NEW MEXICO "CR" STATE

SUNDRY NOTICES AND REPORTS ON WELLS

MARBOB ENERGY CORPORATION

MARBOB ENERGY CORPORATION PROPOSES TO PLUG & ABANDON THIS WELL AS FOLLOWS:

AFTER

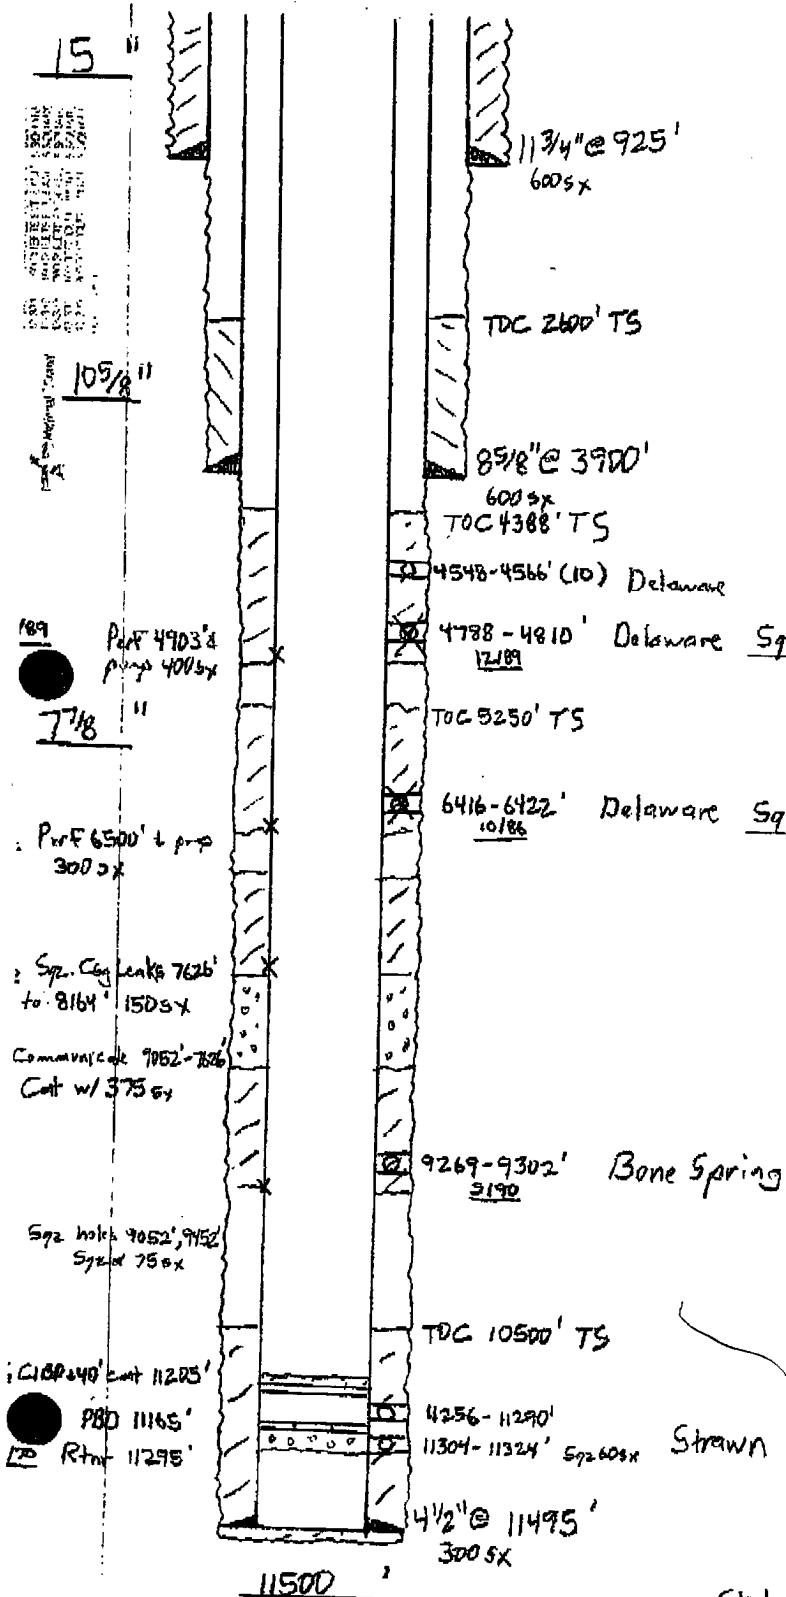
8. SPOT 100' PLUG @ ~~975'-875'~~ - TAG → SPOT 100' PLUG F/400'-300'
